MIL-C-24231/25D(SH)
AMENDMENT 1
2 April 1993

MILITARY SPECIFICATION SHEET

CONNECTOR, HULL INSERTS, TYPE VII

FIGURE 1. Connector, hull inserts - typical.

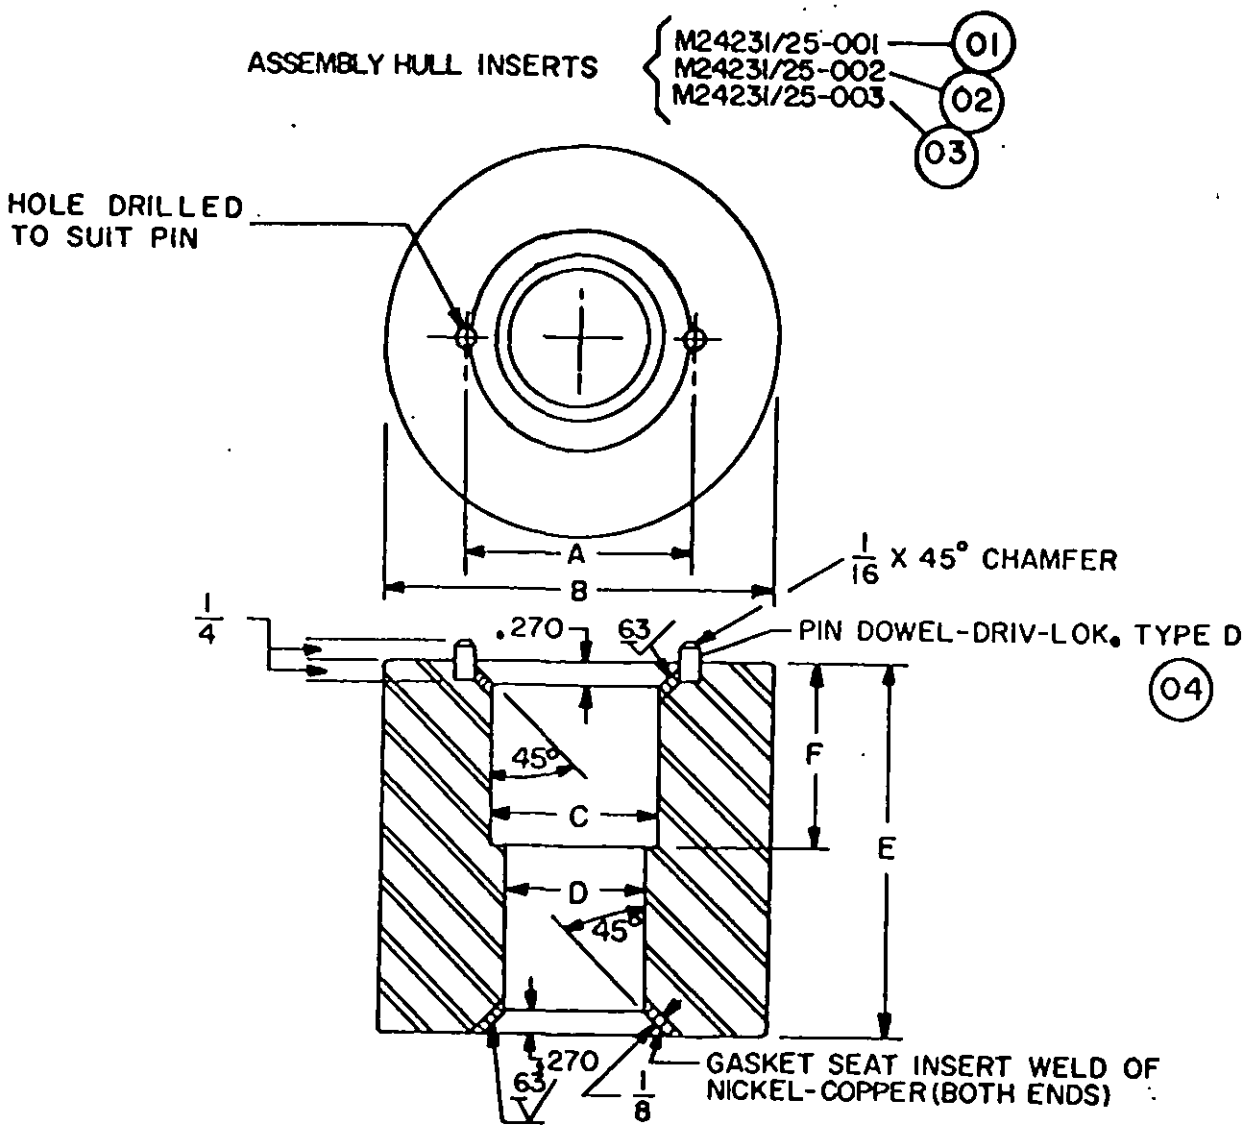
Figure 1: Delete and substitute: (see page 2)
